CHARTER TOWNSHIP OF YPSILANTI

PLANNING COMMISSION

REGULAR MEETING AGENDA

B. **PRELIMINARY SITE PLAN – 10635 TEXTILE ROAD – K-11-24-400-002/003**—TO CONSIDER A REQUEST TO CONSTRUCT A 183,000 SQUARE FOOT LAST MILE DISTRIBUTION CENTER

NFE JOB NO. M278-01
SHEET NO. SP 4.2

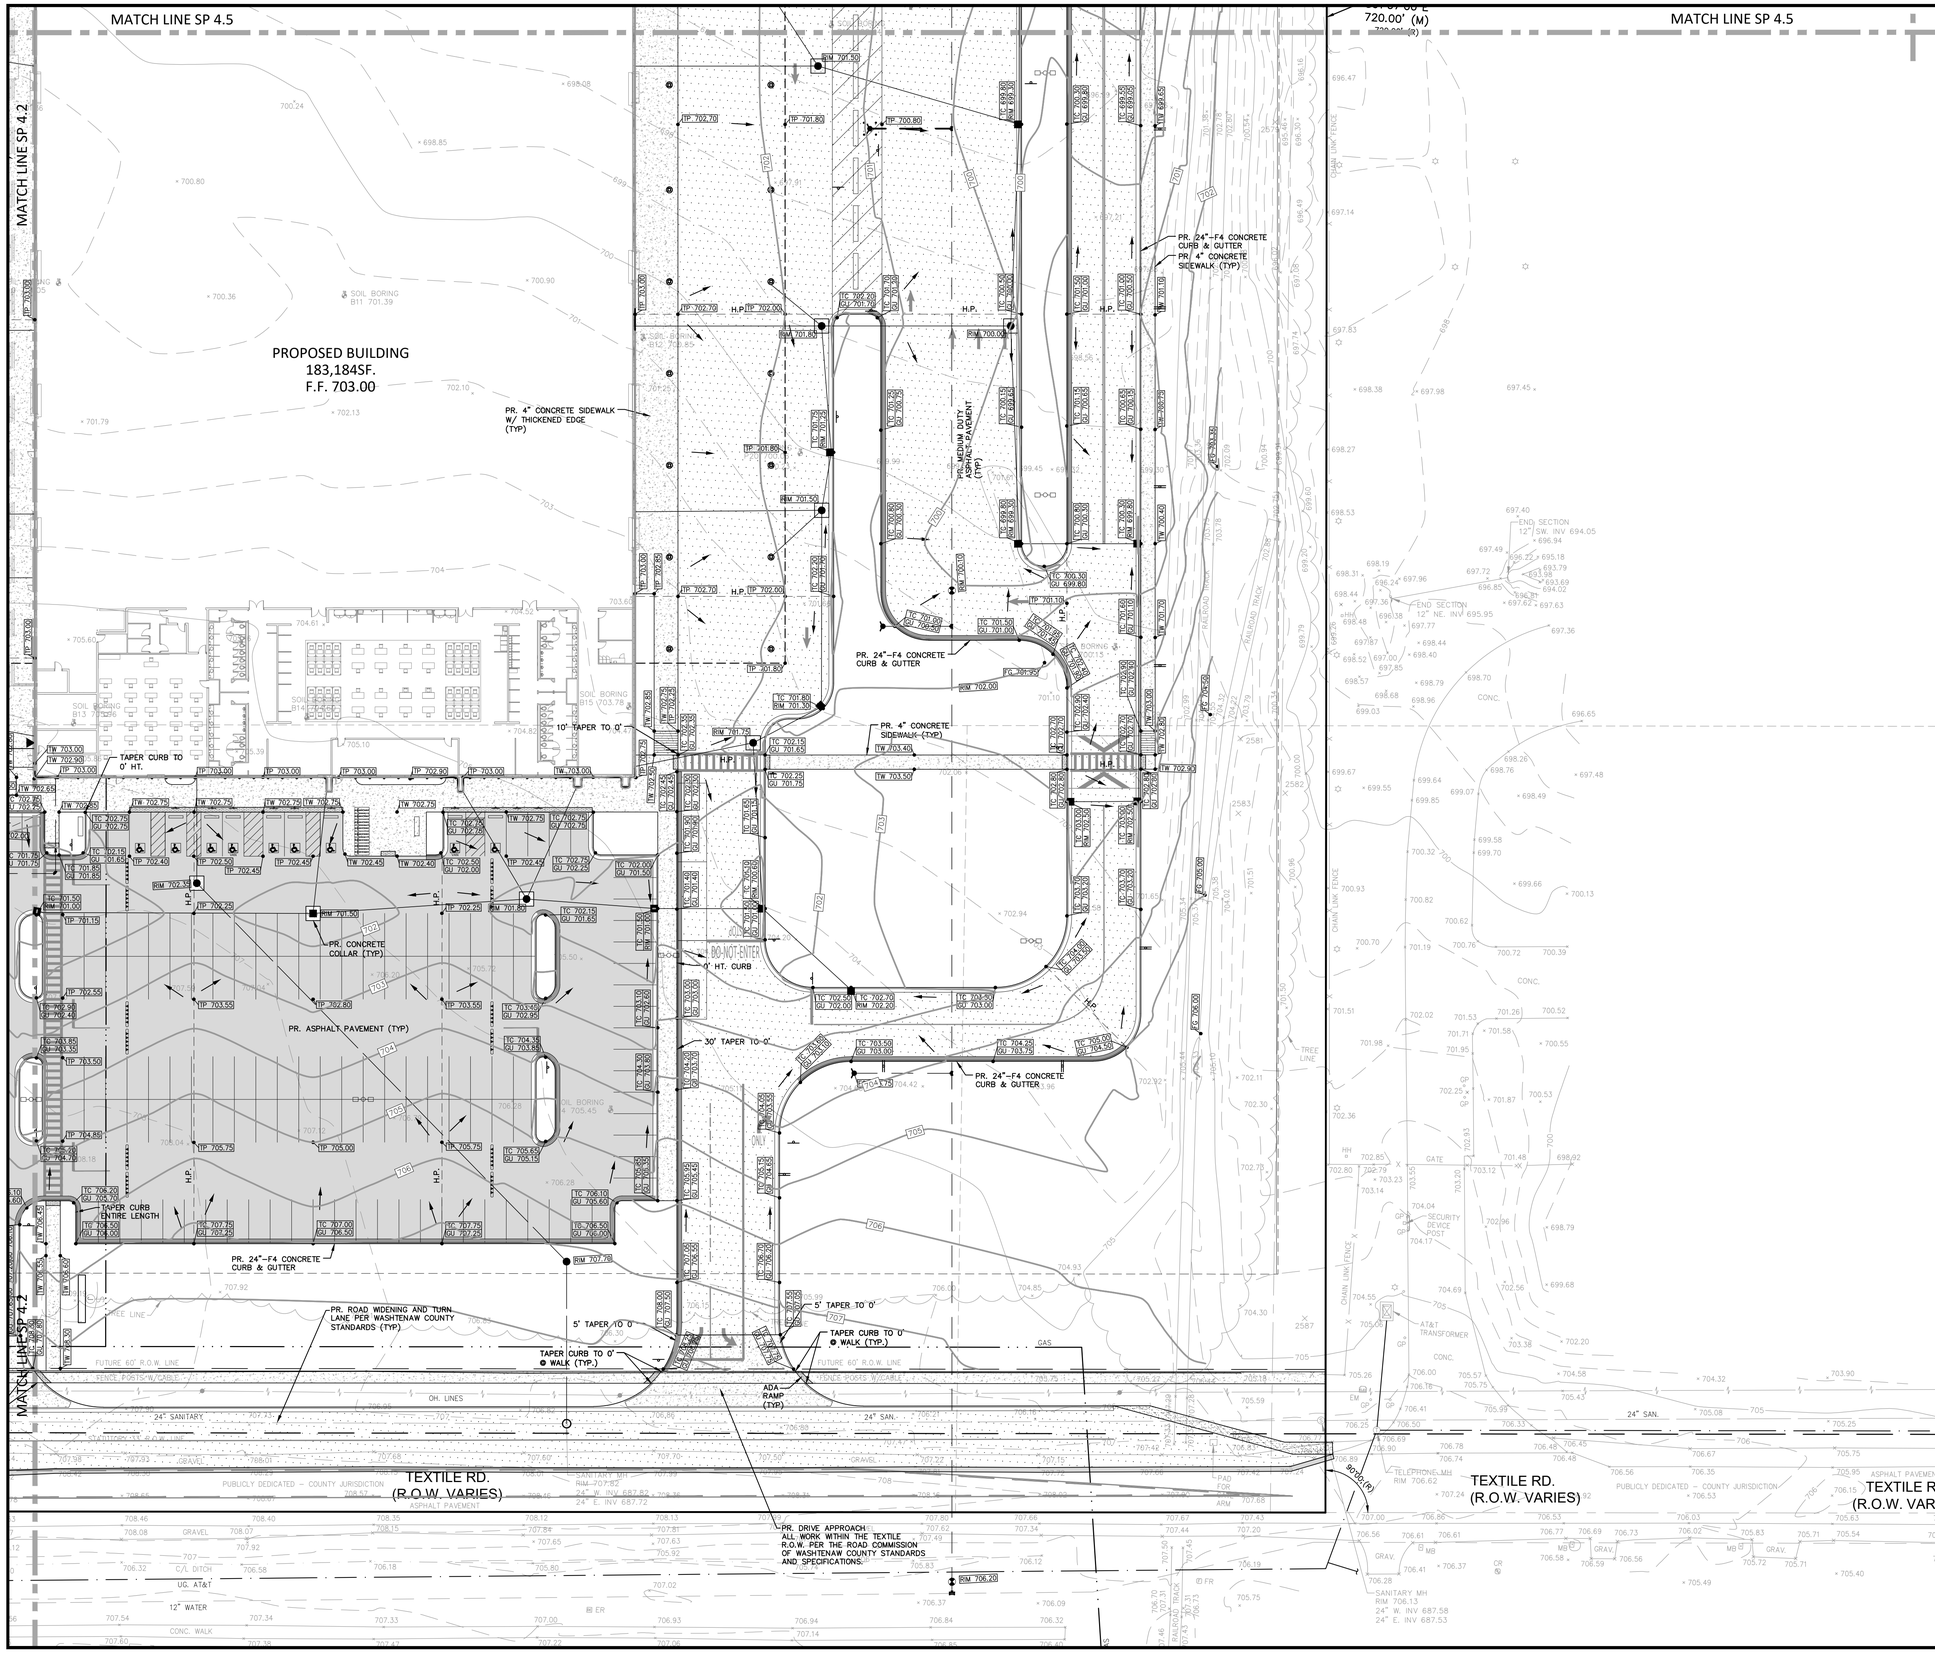
1. Sheet 54, SP 4.2 Paving & Grading Plan:
    a. The proposed contours ending at the right-of-way shall meet proposed contours within the right-of-way.
2. Sheet 55, SP 4.3 Paving & Grading Plan:
    a. The maximum slope for concrete pavement is 6.0%. The area at the entrance to the van staging area shall be revised.
    b. The proposed contours ending at the right-of-way shall meet proposed contours within the right-of-way.
3. Sheet 56, SP 4.4 Paving & Grading Plan:
    a. Proposed grading shall meet abutting property line elevations. The 691 ft. contour at the northwest area of the plan view shall be revised.
    b. The contours at the proposed ramps shall be revised so that they are ADA compliant.
4. Sheet 57, SP 4.5 Paving & Grading Plan:
    a. The sidewalk located near the southwest corner of the parking area should be revised so that it is ADA compliant.

NFE JOB NO. M278-01
SHEET NO. SP 7.9

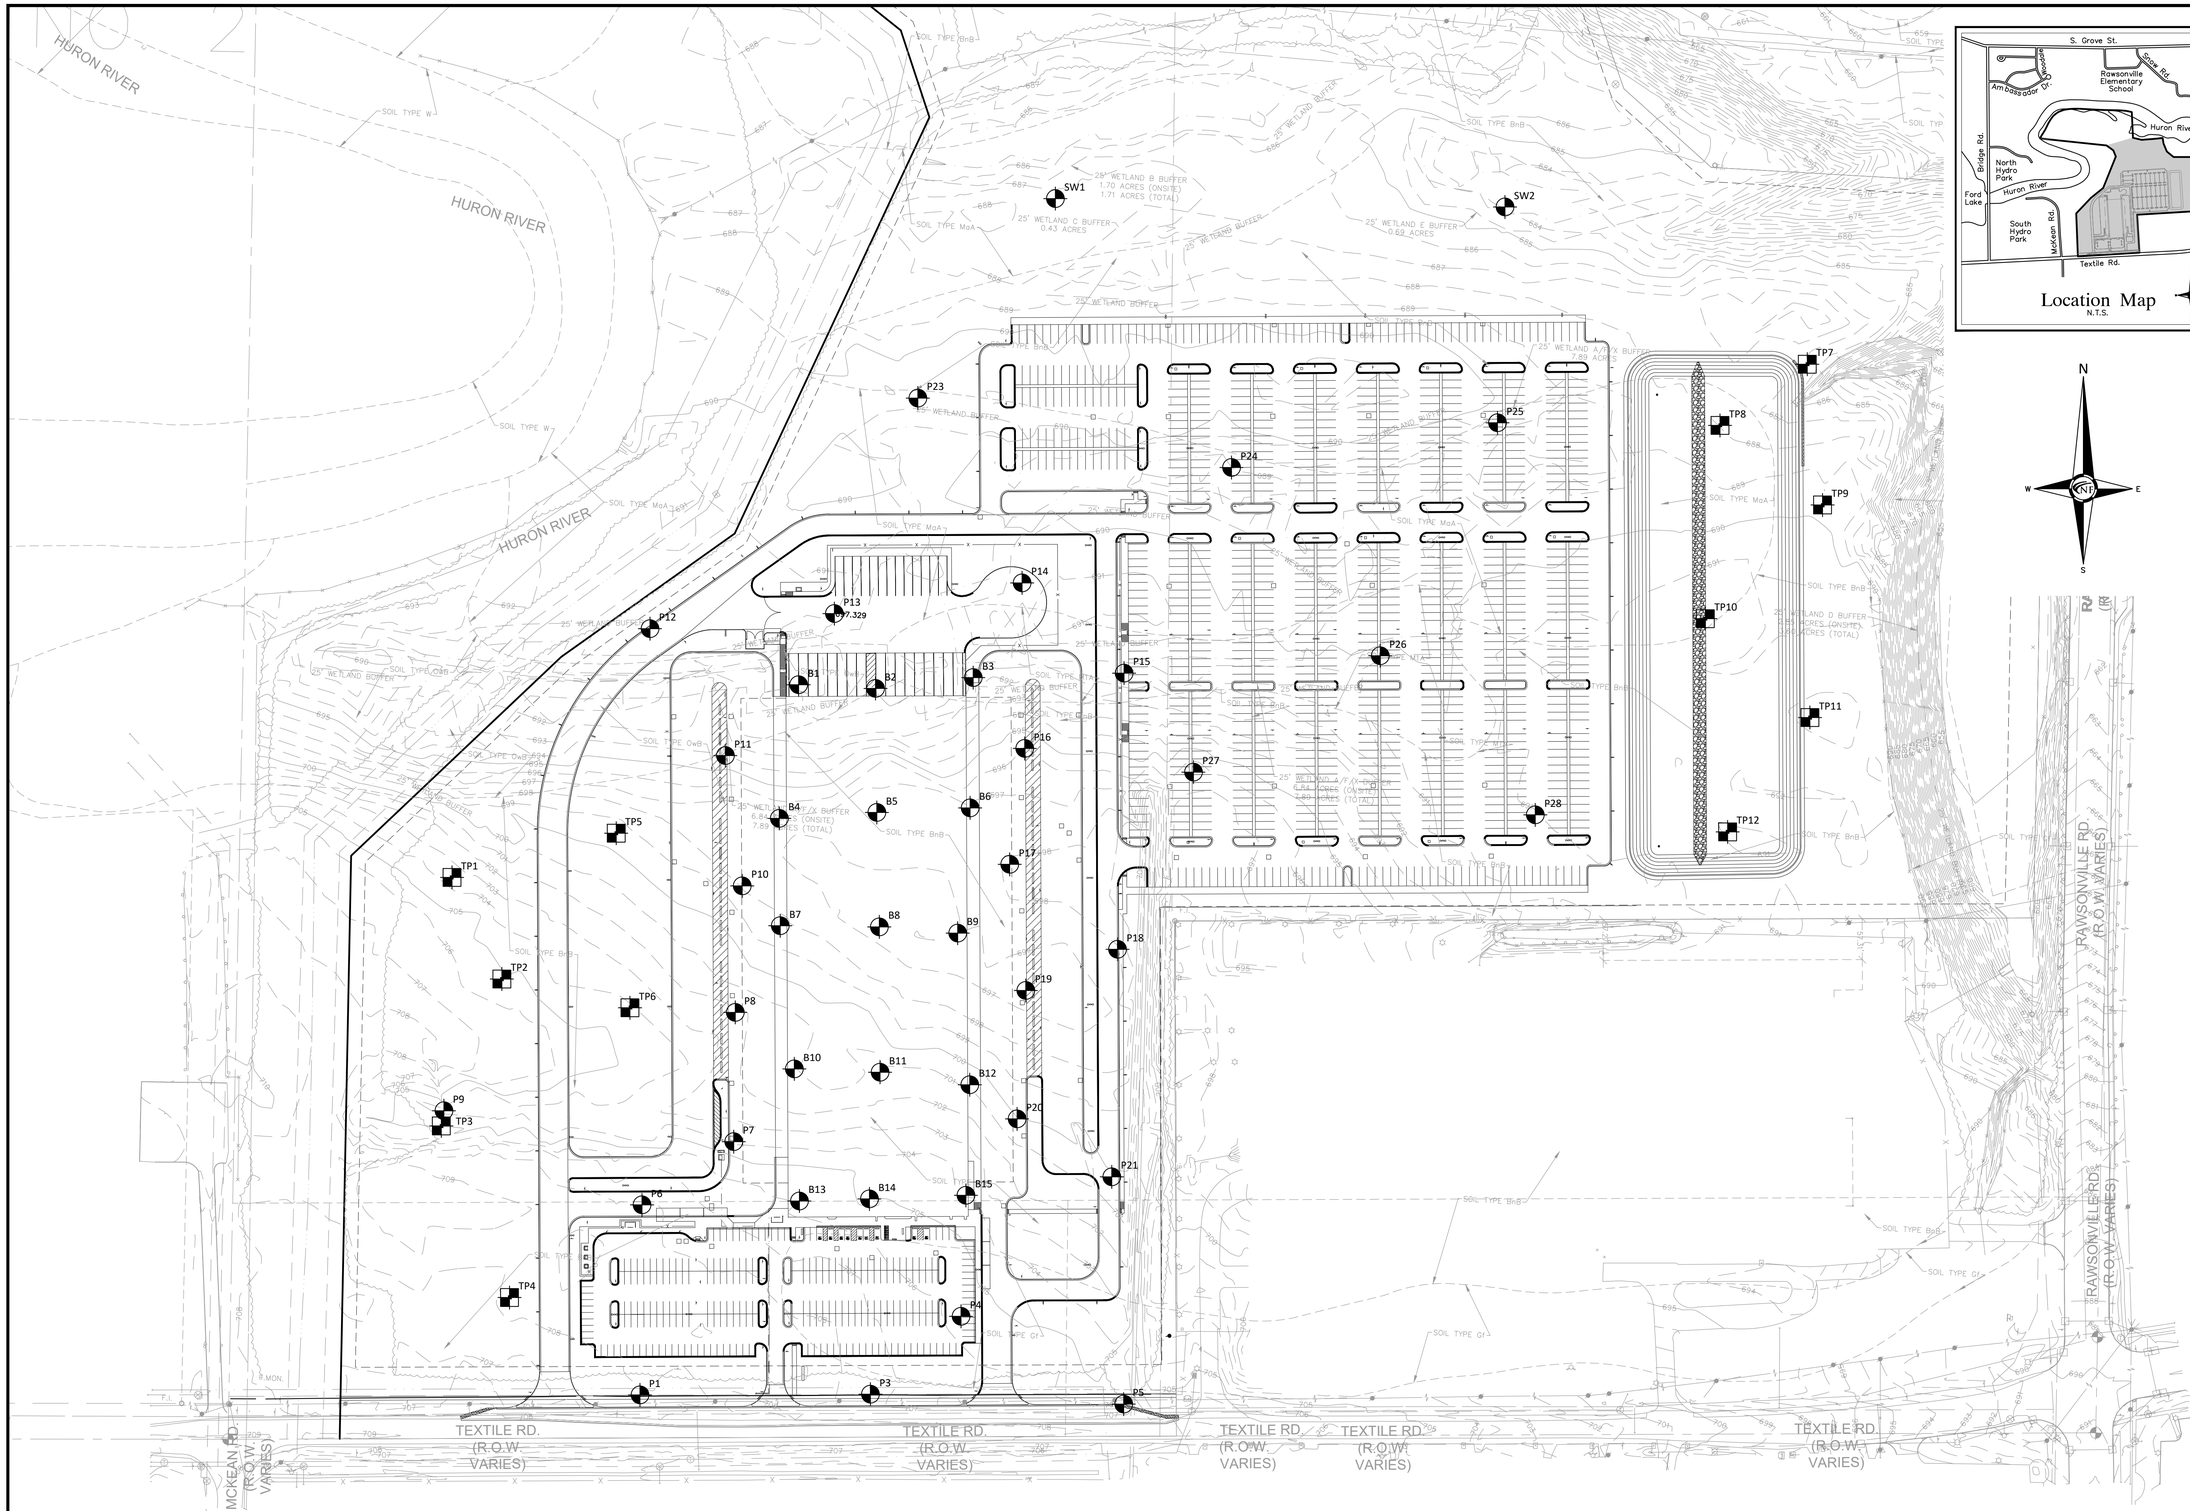
3. Reference to inspection of the infiltration basin in the maintenance plan notes on plan sheet SP 7.9 should be stricken since no infiltration is being provided within the proposed basin.

SHEET NO.
SP 7.11

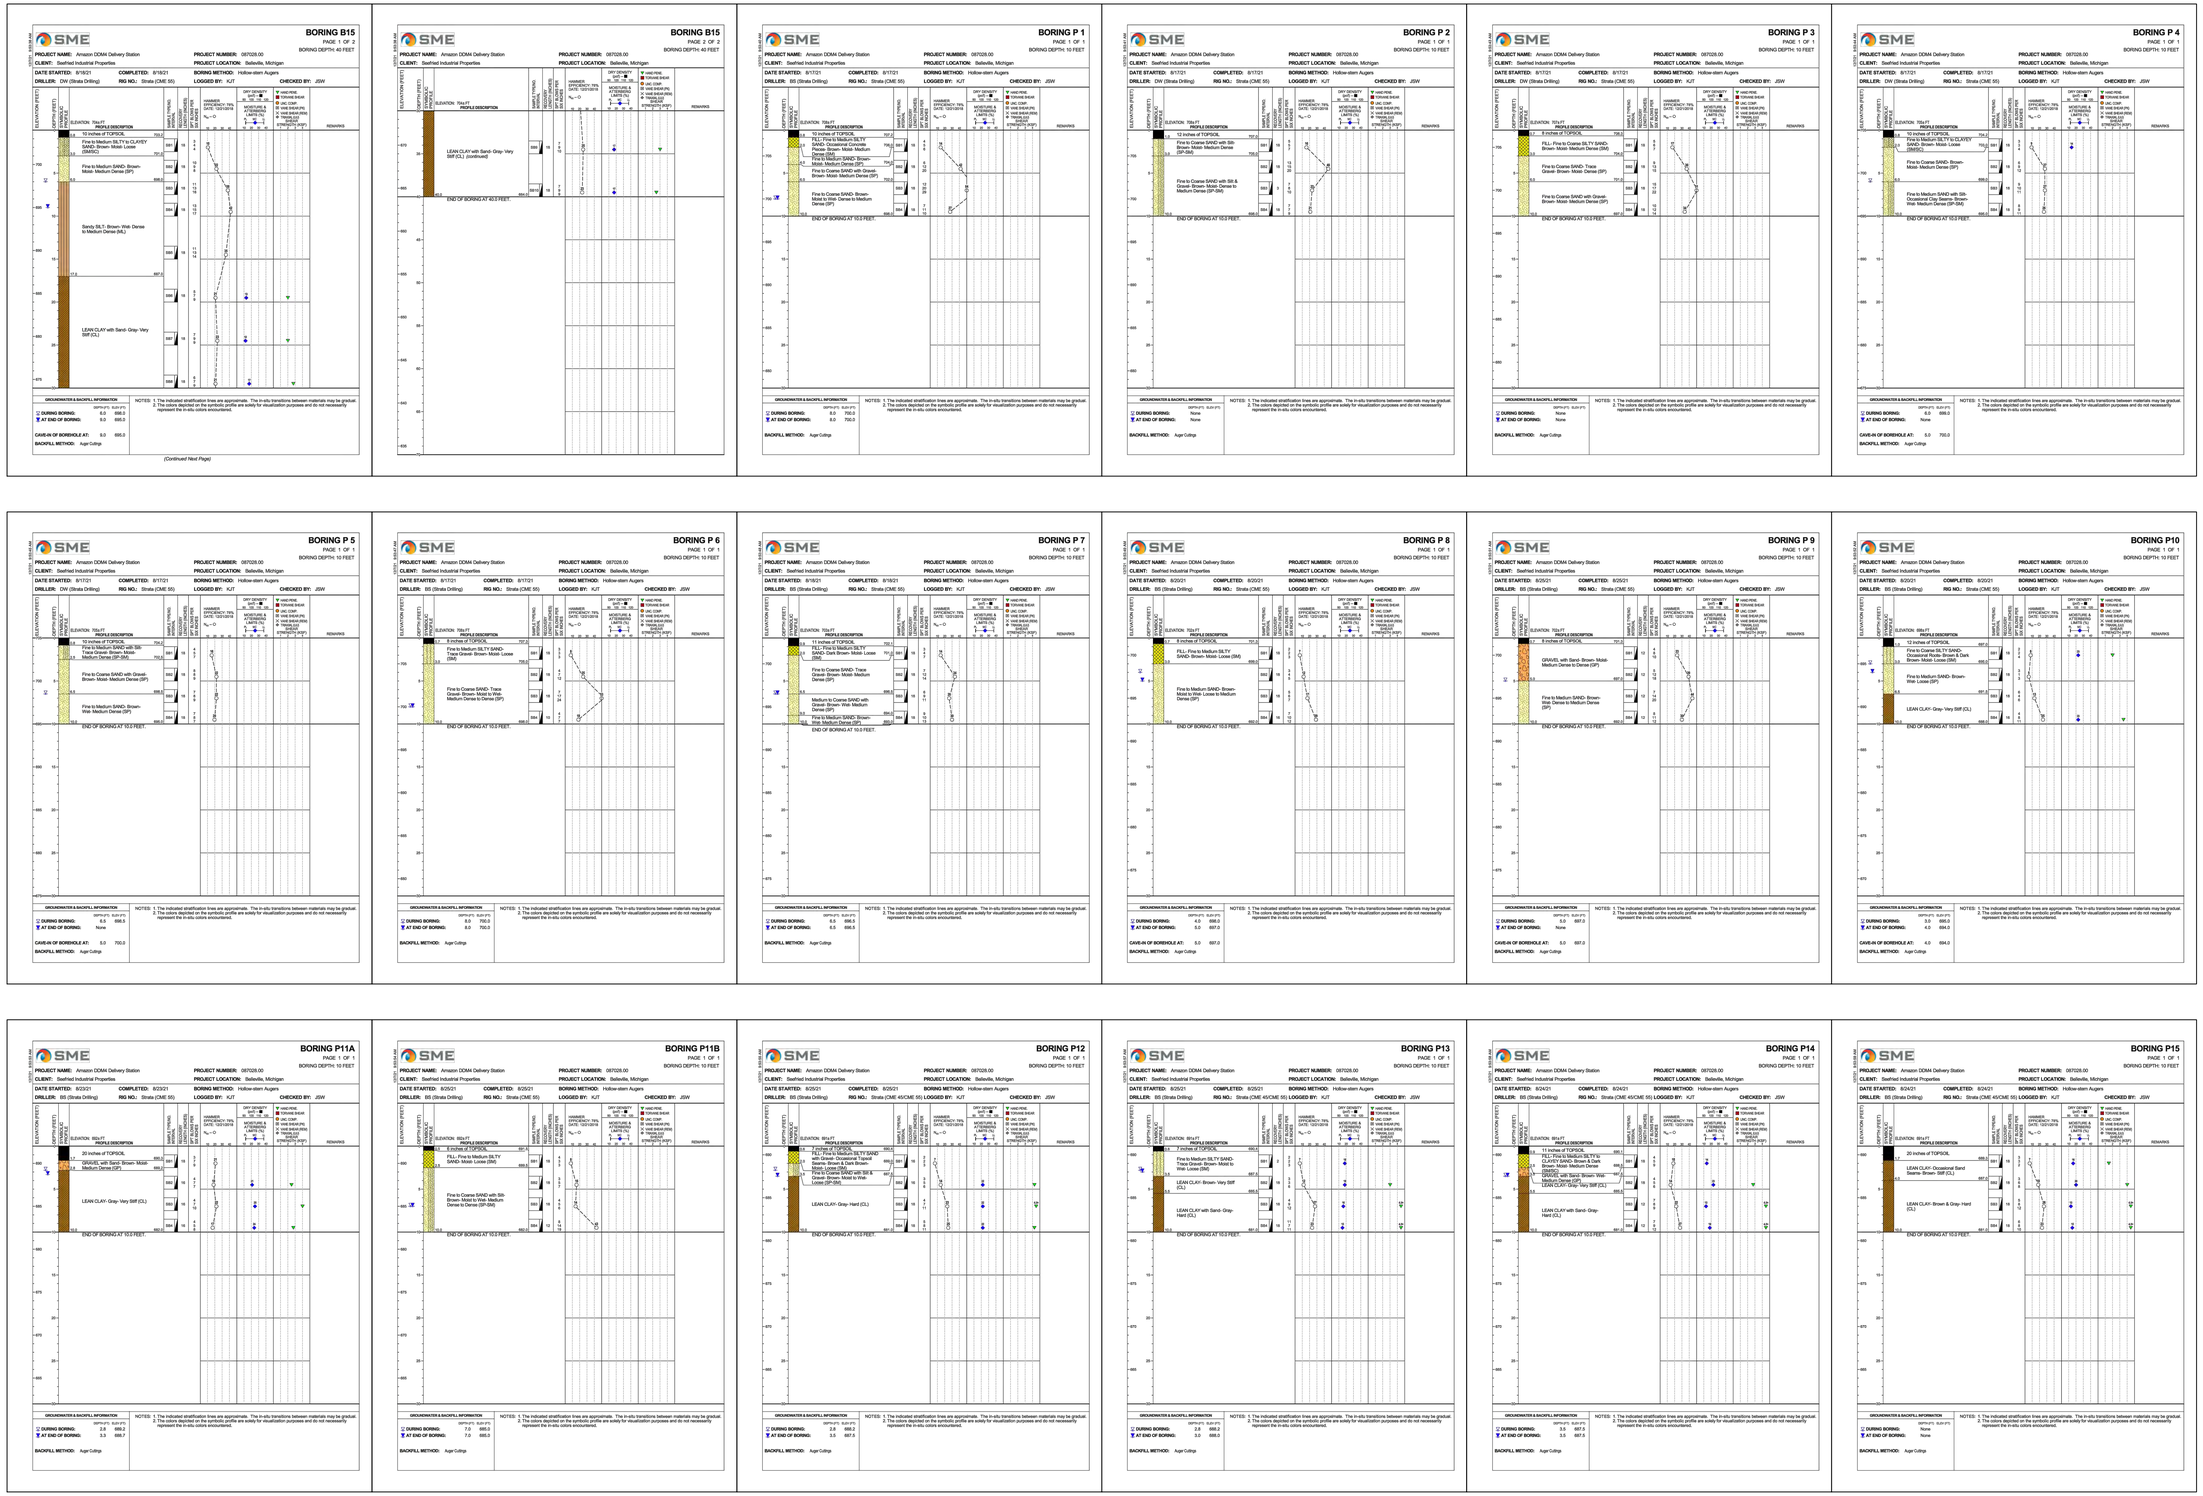
2. Plan sheets SP 7.11 through SP 7.13 are titled, "Infiltration Reports Plan" but do not include the test pit logs from the infiltration testing activities.
